George Vanderheyden
Vice President
Calvert Cliffs Nuclear Power Plant
Constellation Generation Group, LLC

SUBJECT: Calvert Cliffs Nuclear Power Plant
Unit No. 1; Docket No. 50-317
Supplemental Data for Request for Relaxation from Interim Inspection
Requirements for Reactor Pressure Vessel Head (TAC No. MC1921)

RESPONSE TO REQUESTS FOR ADDITIONAL INFORMATION

Figure 1: Illustration of Stress Analysis Mesh Indexed to Node 81401

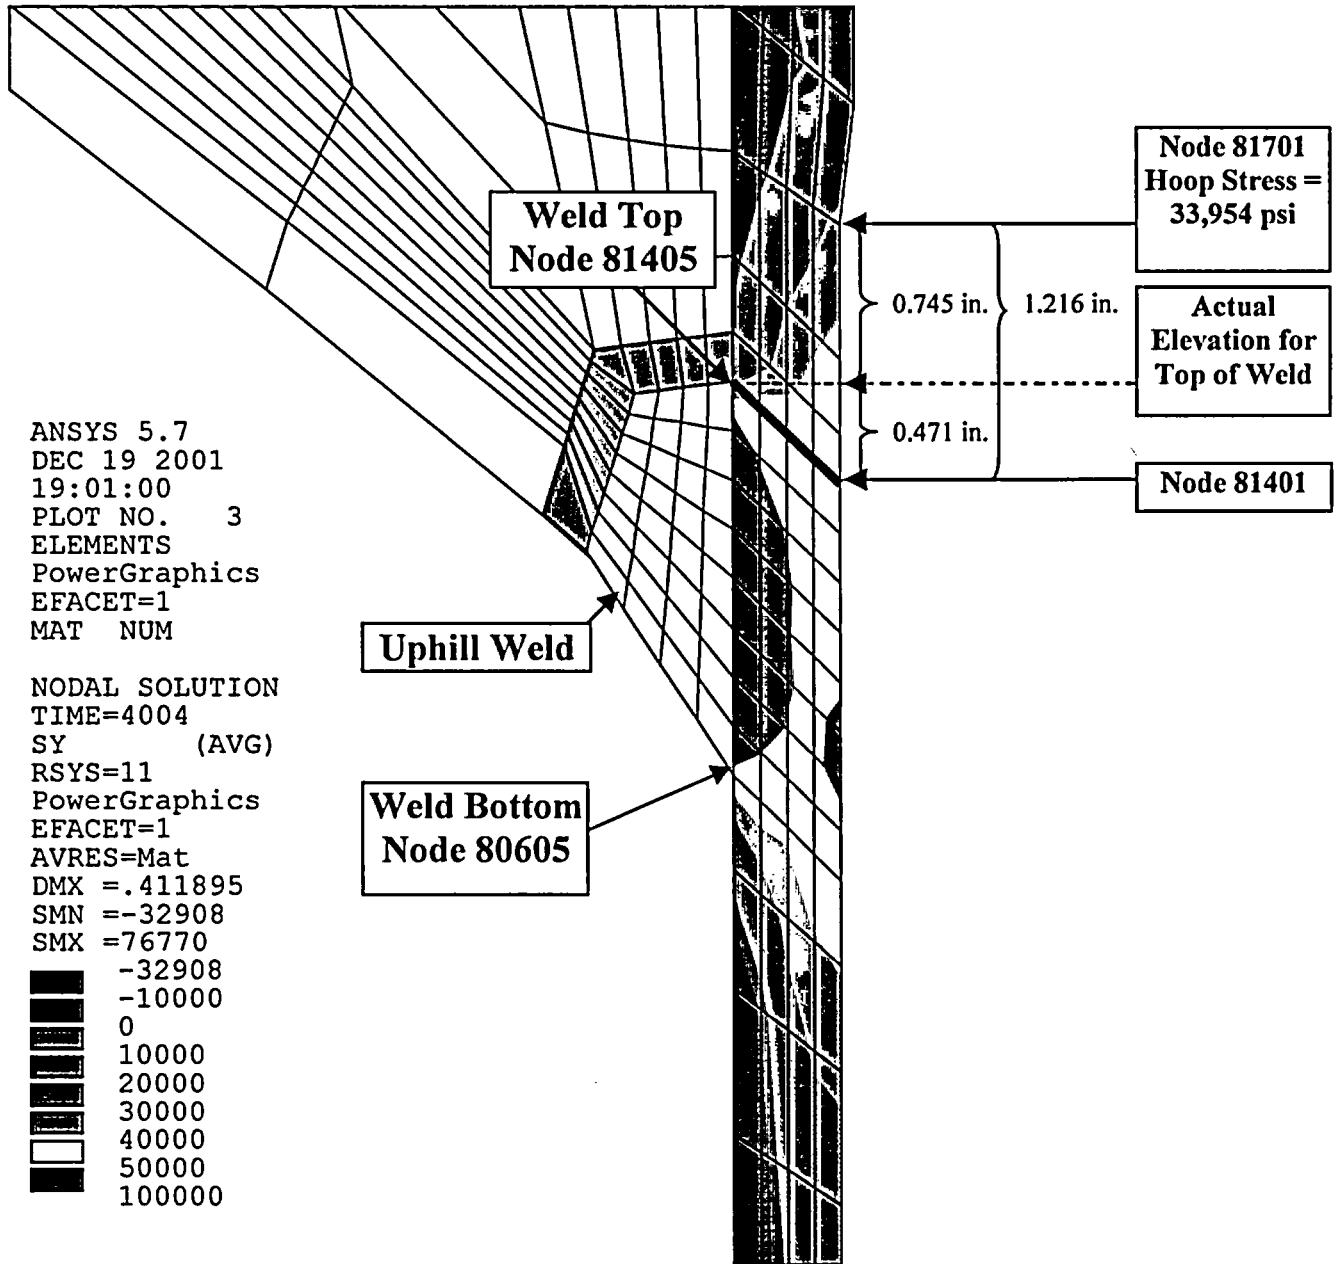
Explain in detail how the absolute elevations of the top and bottom of the weld were obtained.

Provide an example using this methodology. For example, for node 81701 at a 43 degree angle, the distance above the J-groove weld was 1.216 inches and the Hoop Stress calculated in the FEA was 33954 psi.

With the updated post-processing method, a nozzle at 43 degrees with a distance of 1.185 inches above the weld has a Hoop Stress calculated at 16.2 ksi. CCNPP needs to justify this huge discrepancy in stress values.

nodes at the nozzle outside diameter (OD)/weld interface. The bottom of the weld is the lowest node along this interface and the top of the weld is the highest node along this interface. Please refer to Figure 1 where the top and the bottom of the weld for the uphill weld are identified for the 43 degree angle model.

The discrepancy in stress values between the 2003 relaxation request and the 2004 relaxation request is due to a conservative simplification of the model geometry used in 2003 to calculate stresses above the top of the weld at the uphill side. Figure 1 is a plot of the operating hoop stresses at the uphill side of the 43 degree nozzle. The nodes at the top and bottom of the weld are identified, as are nodes of interest on the inside diameter (ID) side of the nozzle.

As shown in the table, nodes 81405 (on the OD) and 81401 (on the ID) were both assumed to be at the same absolute elevation (shown in bold). In fact, node 81405 is at the elevation of the weld root, but node 81401 is below the elevation of the weld root as shown in Figure 1 (by the bold line). In 2003 we reported the stresses on the nozzle ID surface at various distances with respect to 81401 instead of with respect to 81405. The assumption that 81401 and 81405 were at the same elevation simplified the determination of stresses, but provided values that were conservatively high.

The stress at node 81701, which is 1.216 inches above node 81401, is 33,954 psi. The stress at this node in 2004 is that same as it was in 2003. As shown in Figure 1, this stress value agrees with the stress contours of the hoop stress plot.

In 2004, it was decided to report ID stresses in reference to the location of the top of the weld. As shown in Figure 1, node 81701 is actually only 0.745 inches above the top of the J-groove weld.
